SUBJECT: #258-12 BH NORMANDY RIVERSIDE, LLC/MASSACHUSETTS BAY TRANSPORTATION AUTHORITY petition for a change of zone to Mixed Use 3/Transit Oriented District for a portion of land located at 327 Grove Street, also identified as Section 42, Block 11, Lot 3A, currently zoned Public Use.

#258-12(2) BH NORMANDY RIVERSIDE, LLC/MASSACHUSETTS BAY TRANSPORTATION AUTHORITY petition for a SPECIAL PERMIT/SITE PLAN APPROVAL to construct a mixed use, transit-oriented development including an office building of approximately 225,000 sq. ft., a residential building containing 290 apartments with 5,000 sq. ft. of retail space, a three story building containing approximately 15,000 sq. ft. of retail space and approximately 8,000 sq. ft. of community space, and related site improvements; to permit office use on the ground floor, medical office use, retail and personal establishments of more than 5,000 sq. ft., eating and drinking establishments of more than 5,000 sq. ft., retail banking and financial services, and health club establishments on the ground floor; and reduced minimum setbacks of side setback of office building, and front setback of retail/community building; parking facility design st

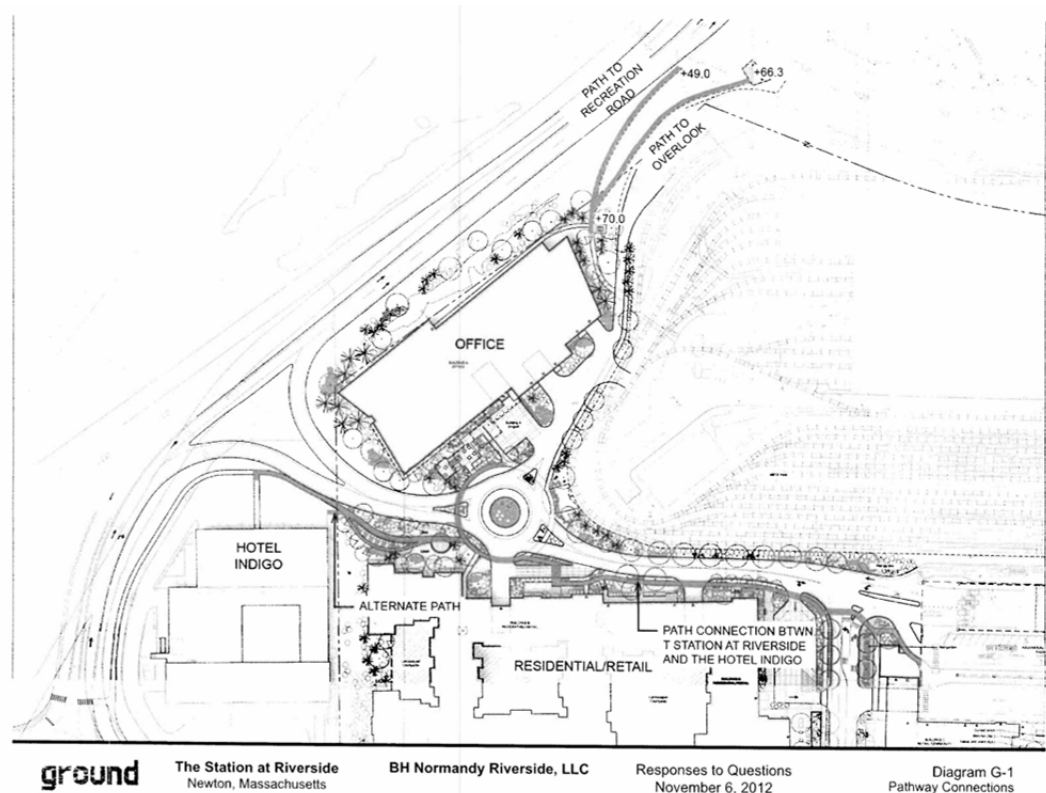
2. Could the travel lanes on Grove Street be narrowed to allow for wider bike lanes? This question was asked both at the public hearing and by FST, the City's peer reviewer. The developer responded, "Consistent with the directives by the City throughout the development of this project, the width of improvement along Grove Street has been minimized to remain consistent with the current character. Also as requested, bicycle accommodation has been maintained as part of this plan within the currently proposed

roadway configuration. Expanding the roadway by two feet to increase the bike accommodation by one foot in each direction does not appear necessary.” (VHB memo dated October 15, 2012, p. 12). The Planning Department continues to encourage the developer to design the bicycle lanes along Grove Street to as close to five feet as possible. The developer’s response does not seem to address the question of whether the vehicular travel lanes could be narrowed in order to accommodate wider bike lanes. Neighbors at the Riverside Business Center prefer *not* to see lane widths reduced out of concern that it will slow traffic to their location. Thus, the interests of users of all modes of transportation need to be balanced to accomplish several objectives. As a multimodal center on a scenic road, it is important to enhance alternatives to the automobile, and some modest trade-offs between vehicular lane width, bike lane width, and median width while maintaining the trees on the south side of the road deserve a closer look.

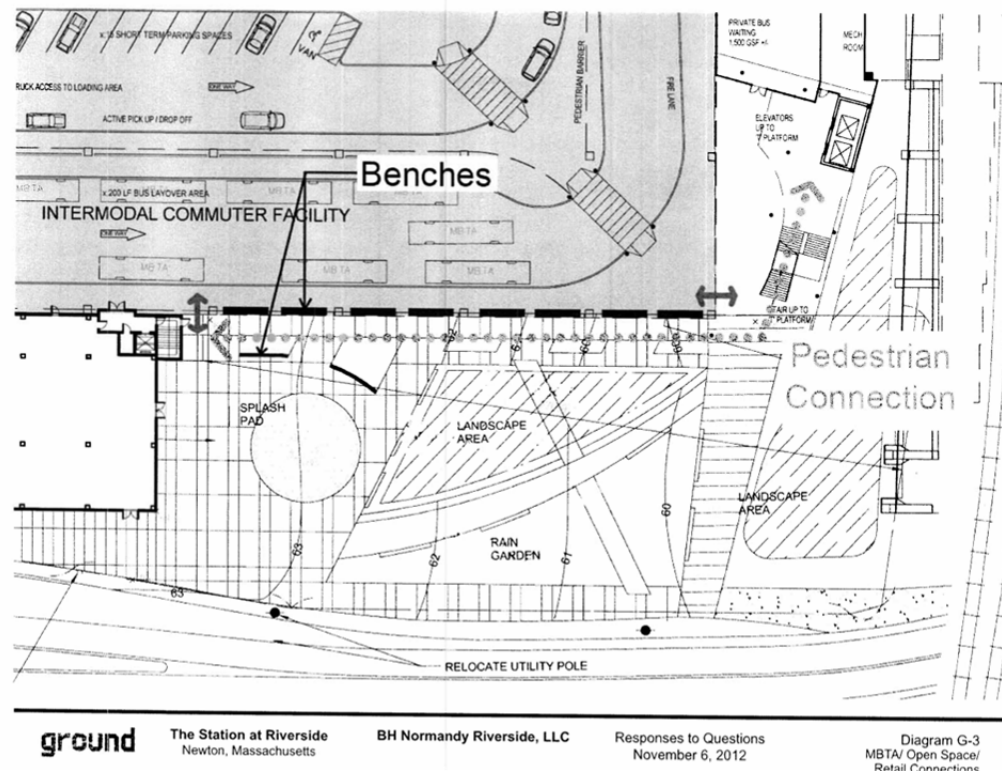
- Could the developer provide more details about the interrelationship between the retail area and open space with the MBTA ICF?** Retail space is attached to the ground floor of the Grove Street side of the MBTA facility with open space separating it from Grove Street. The open space and the retail both benefit from the movement of people coming and going from the surrounding neighborhoods to the MBTA station. People will be crossing the park, using the benches, or grabbing coffee or snacks from the retail businesses. It is intended that the MBTA facility be visibly porous at the ground level, yet be designed to avoid any dangerous conflicts between pedestrians and vehicles. People who park in the MBTA facility will be able to get to the retail shops by way of two primary connections between the garage and the open space: the first is at the elevator to the community space and upper garage levels, and the second is at the stairway up to the train level. The remainder of the south edge of the MBTA facility will include benches that provide seating for the bus users as well as to discourage cross movement.

The landscape design reinforces the selective separation of the MBTA facility and the open space with planting beds and trees lining the edge of a pathway along the MBTA façade, and seat walls that define the edge to the children's splash fountain area, providing a physical barrier. This design is detailed in the diagram shown above.

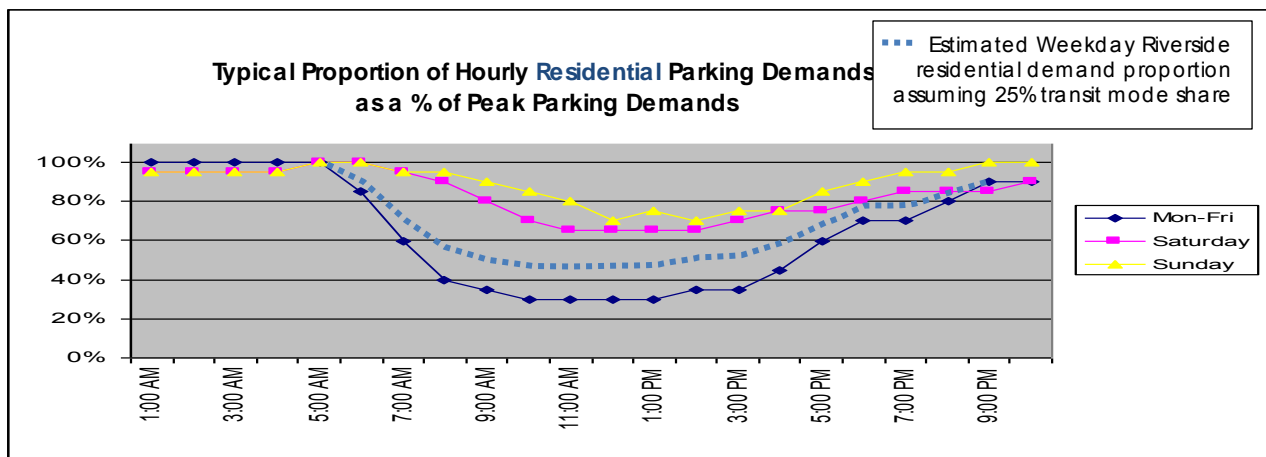
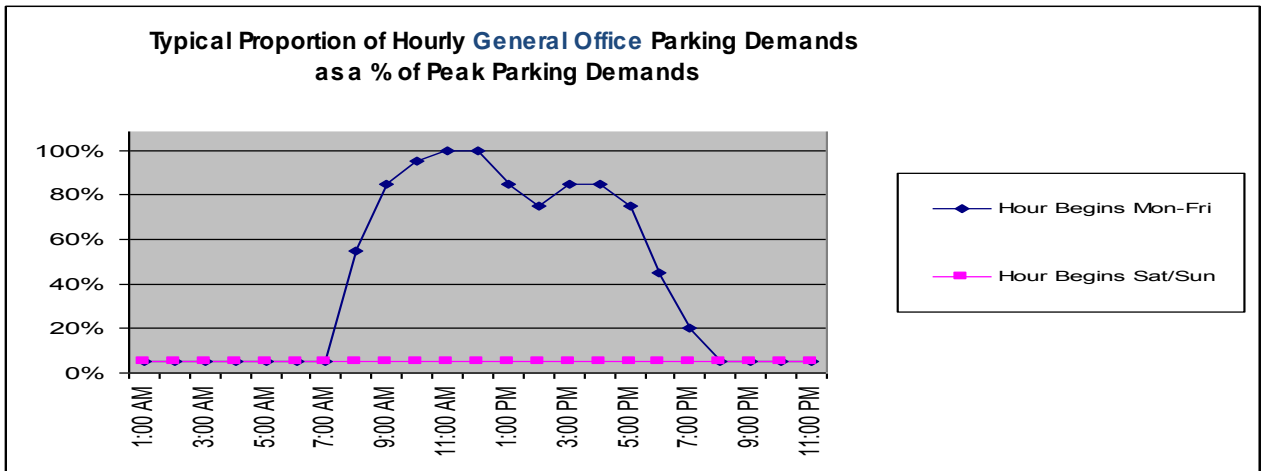
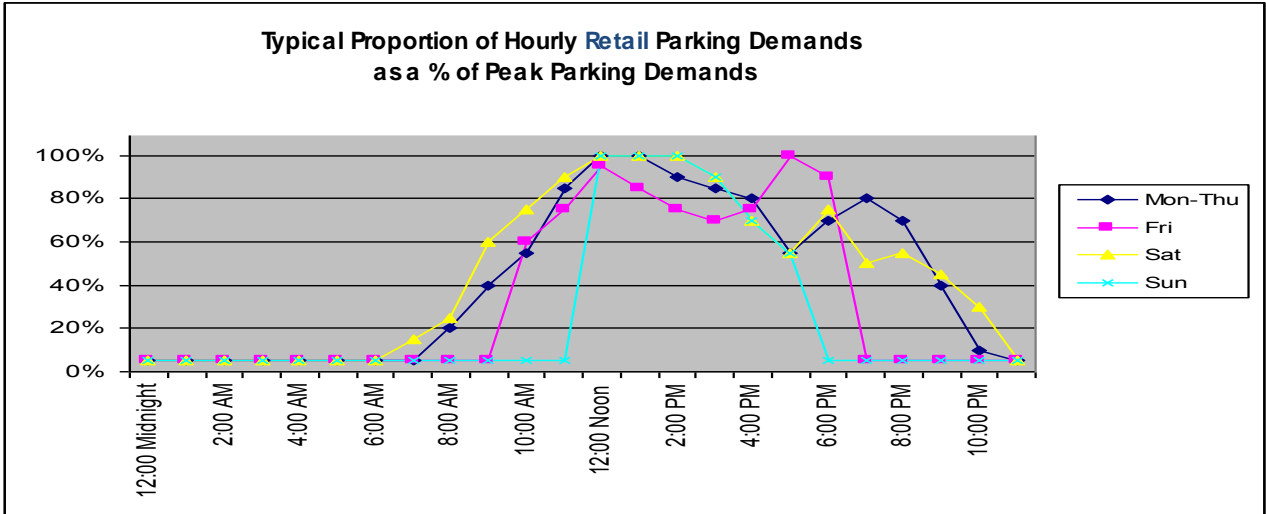
Within the Building B parking garage, the Applicant proposes tandem parking, which we believe is not a good way to control parking operations. The 26 tandem spaces would affect traffic and parking operations of a total of 54 parking spaces. Use of the tandem parking spaces may be space-efficient, but provides an inefficient, non-user friendly way to accommodate 12% of the parking supply associated with Building B. Maneuvers into or out of these spaces will be constricted, as the normally require two drivers to be present when a vehicle in an interior tandem space is being moved.

It is not clearly presented how the 12 surface spaces associated with Building ‘B’ will be controlled. Are these to be time controlled, metered or left uncontrolled?
